Kirtland Air Force Base is submitting an Addendum to the Light Non-Aqueous Phase Liquid (LNAPL) Containment Interim Measures Work Plan Part 1 - Characterization, Bulk Fuels Facility Spill, Solid Waste Management Units ST-106 and SS-111. The original LNAPL Containment Work Plan was submitted to you in July 2011.

LNAPL Containment Workplan Addendum for the Bulk Fuels Facility Spill, SWMUs SS-111 and ST-106

**Subject: LNAPL Containment Well Location and Installation  
LNAPL Containment Interim Measures Work Plan Part I - Characterization, Bulk  
Fuels Facility Spill, Solid Waste Management Units ST-106 and SS-111  
Addendum November 2011  
Albuquerque, New Mexico**

FIGURE 3

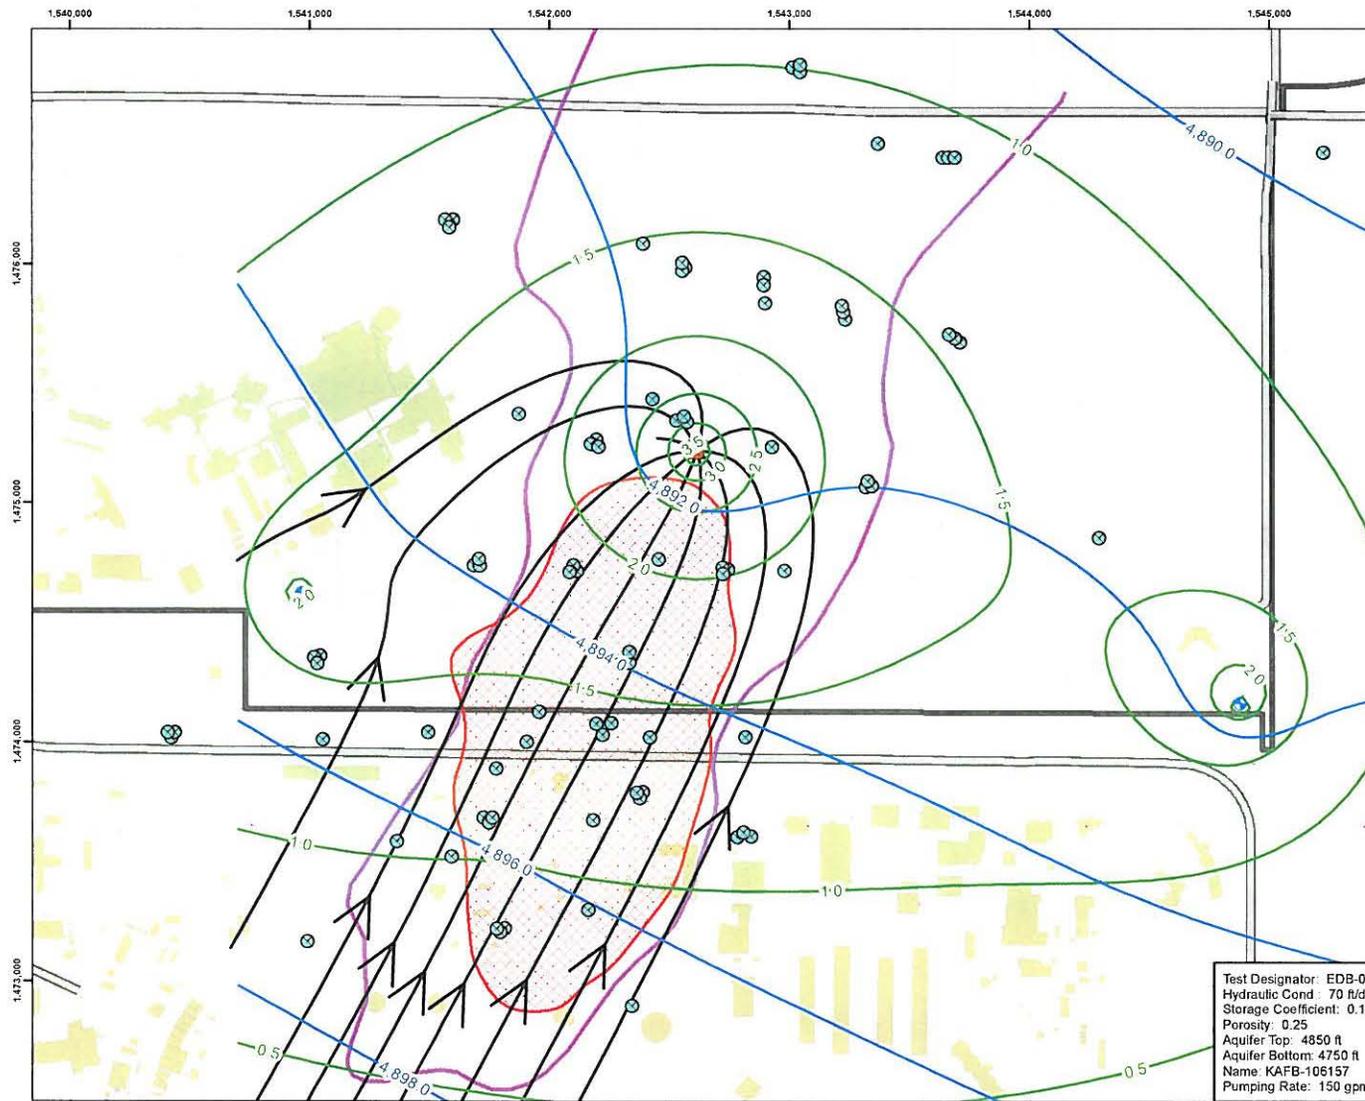
Shaw conducted a technical evaluation of the proposed containment well location and quantity as a result of discussing with the NMED Tiger Team on 3 November 2011. As a result of that evaluation, Shaw determined that a single containment well would be sufficient for containing the LNAPL, meeting the primary objective of the containment system and work plan. The proposed change is to move KAFB-106157 approximately 180 feet southeast of the original location (Figures 1 and 2). Figure 3 shows the predicted capture zone of this containment well, using the most recent hydrogeological data and recently acquired production well data for both Kirtland Air Force Base (AFB) wells and the Albuquerque Bernalillo County Water Utility Authority (ABCWUA) wells.

**Figure 4. Extraction Well Construction**

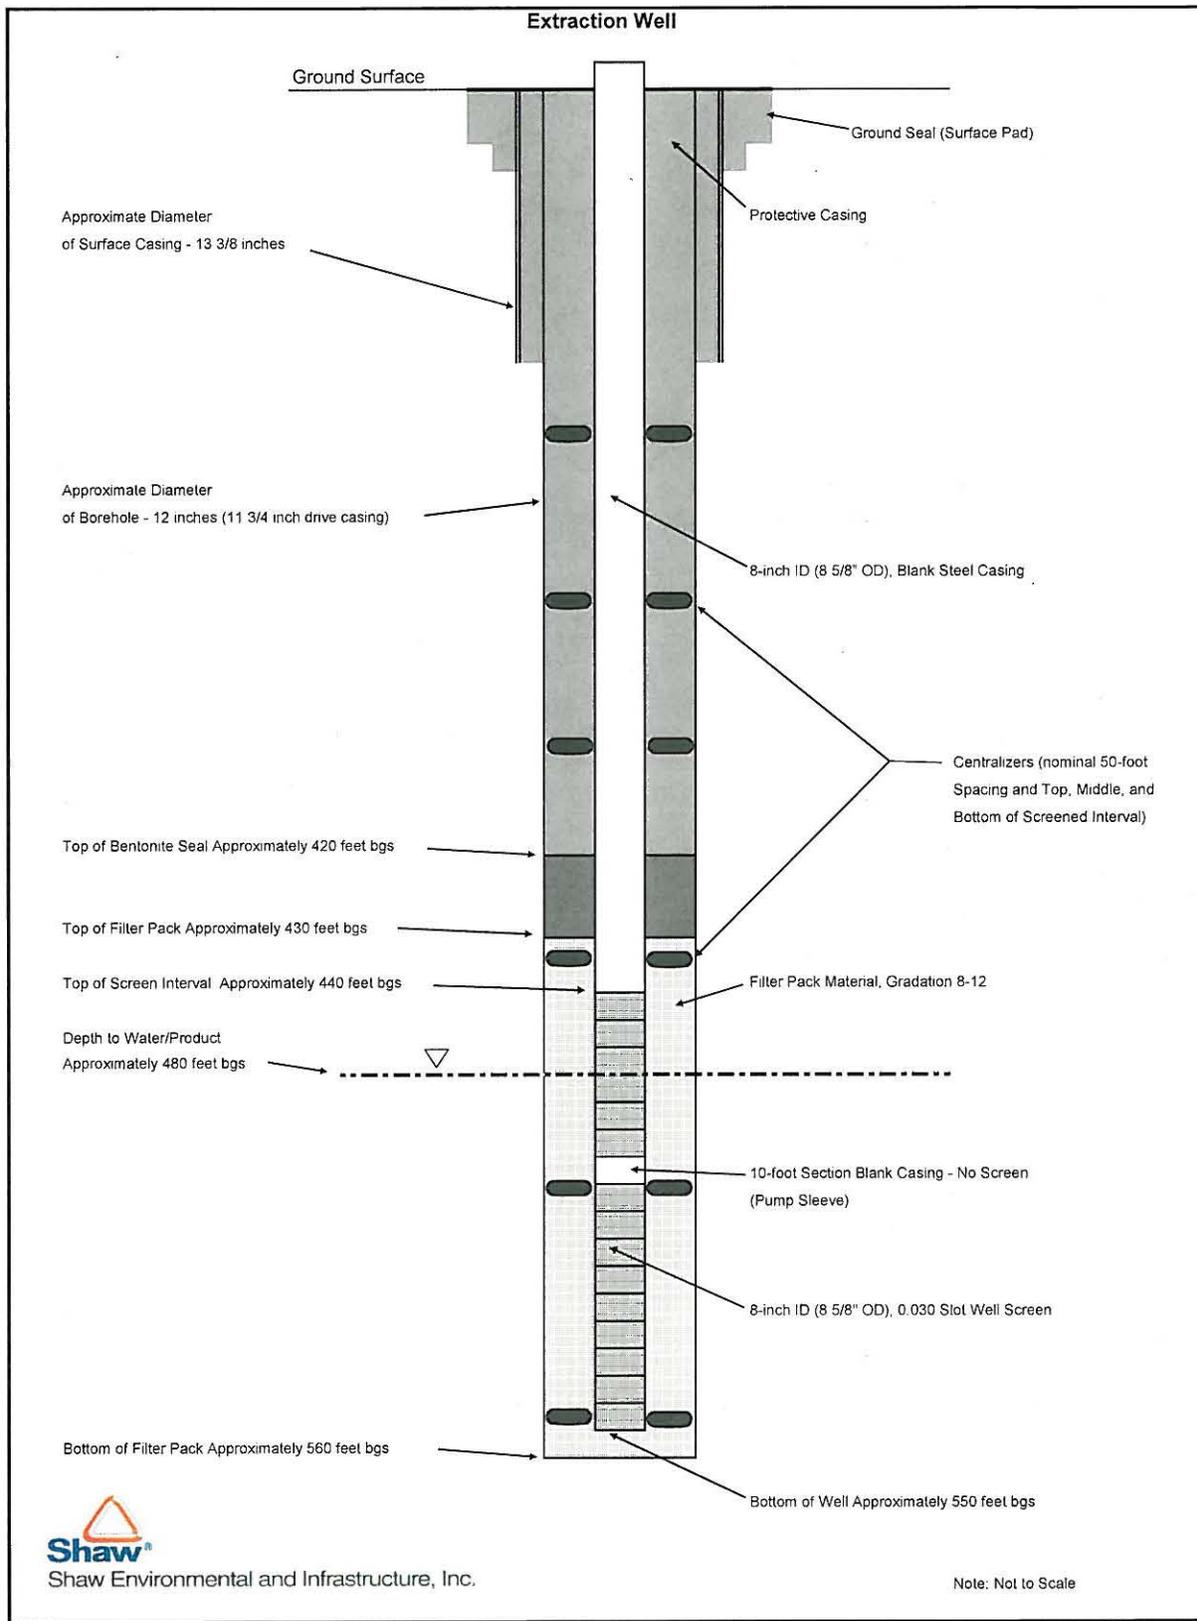
In order to accommodate the documented rise in water levels in the project area, the screening interval of the LNAPL containment well has been revised from what was proposed in the work plan. Figure 4 is a schematic diagram of the proposed well construction. Below is the proposed procedure and well design for the LNAPL containment well KAFB-106157:

- KAFB-106157 will be constructed with 90 feet of 8-inch diameter welded joint 0.030 slot stainless steel continuous wrap screen with double strong wires and rods, a 10-foot blank stainless steel pump sleeve section placed approximately 30 feet below the current water table, and a Schedule 40 carbon steel casing riser (Figure 2). The well will be constructed with 60 feet of screen/pump sleeve below the water table and 40 feet of screen above the water table to accommodate future water table rises. The steel well casing will extend approximately 2.5 feet above grade as a temporary completion during well development. The final depth of the pump sleeve will be decided in the field based on lithology encountered during drilling.

- An engineered 10-20 sand pack filter pack will be installed in the annular space between the well casing/screen and the borehole from the bottom of the borehole to approximately 10 foot above the top of the screened interval. The filter pack will be slurried with clean potable water and tremied into place to prevent bridging and to ensure continuous placement, while the drive casing is slowly removed. A 10-foot hydrated bentonite seal will be emplaced above the sand filter pack and incrementally hydrated with potable water in 1-foot lifts.
